CITY OF BEVERLY HILLS
DEPARTMENT OF PUBLIC WORKS
345 N. FOOTHILL ROAD
BEVERLY HILLS, CALIFORNIA 90210

ADDENDUM NO. 1

LIBRARY ADMINISTRATION STAFF OFFICES IMPROVMENTS PROJECT

DATE OF ADDENDUM: JULY 23, 2019

SECOND LEVEL NEW CONSTRUCTION PLAN
 SCALE: 1/8"=1'-0" 2

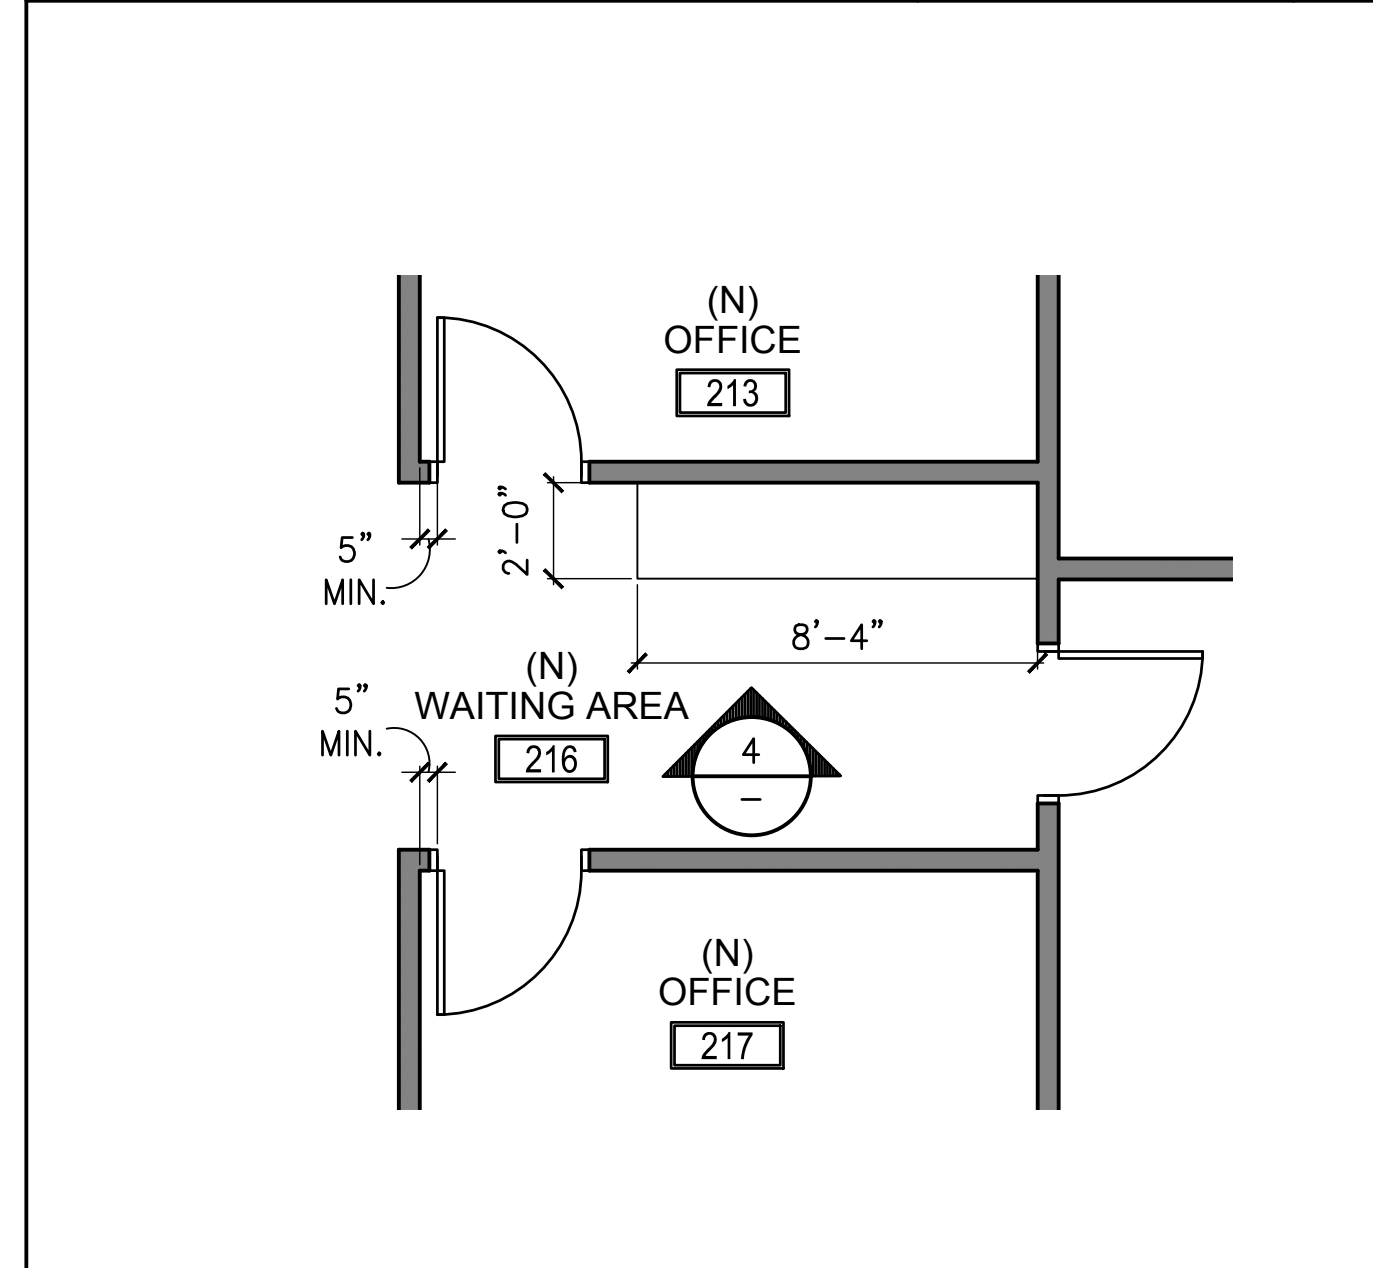
- 3.2 Refer to sheet #A1.11 Second Level New Construction Plan, keynote #14 and #15. Keynote shall apply to (E) northern side corridor walls.
- 3.3 Refer to sheet #A1.11 Second Level New Construction Plan. Door #225 shall match Door #201A in type, size and finish.

- 3.4 Refer to sheet #A1.11 Second Level New Construction Plan. (N) Office #215 East & South Wall indicate new glazing within (E) opening. Image of (E) openings are attached in Exhibit ‘B’.

- 3.5 Refer to sheet #A1.11 Second Level New Construction Plan and sheet #A1.12 New Construction Reflected Ceiling Plan. Provide two (2) new 2’x4’ light fixtures in (E) Office #225 located on the southwest corner. Light fixture to match new specified fixture. Revised Sheet A1.11 is attached in this Addendum.
